## ***Interactive comment on “Assessment of co-benefits of black carbon emission reduction measures in Southeast Asia: Part 2 emission scenarios for 2030 and co-benefits on mitigation of air pollution and climate forcing” by Didin Agustian Permadi et al.***

Anonymous Referee #2 Received and published: 11 September 2017

Figure 2: Simulated annual average concentrations of BC and  $PM_{2.5}$  for BY2007, BAU2030 and RED2030 in  $\mu g/m^3$

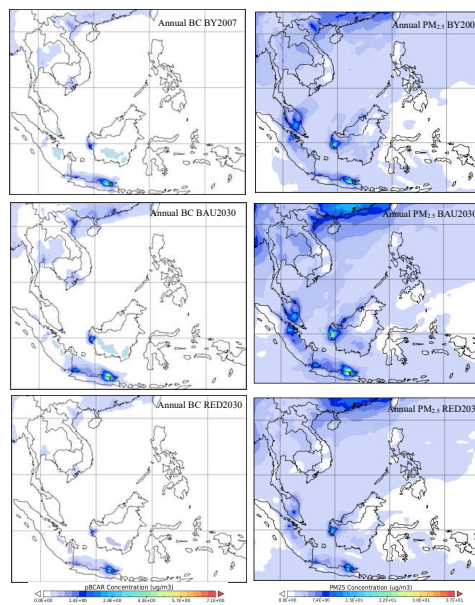
13) Figure 3. Very strange to see areas outside of Jakarta would have the same impacts as Jakarta. As shown in Figure 2, high concentrations of PM2.5 and BC

Figure 3: Change in the number of mortality cases between BAI2030 and BY2007, and between BAI2030 and RED2030 (cases/100,000 population)

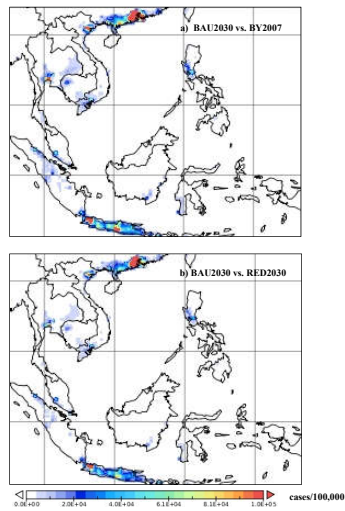
are found in Jakarta, not other places in the island. However, the mortality cases in Figure 3 are all red for the island.

Response: Thank you for the suggestion. We improved the plot and color scale for the high mortality rate in the revised version of the manuscript (Figure 3).
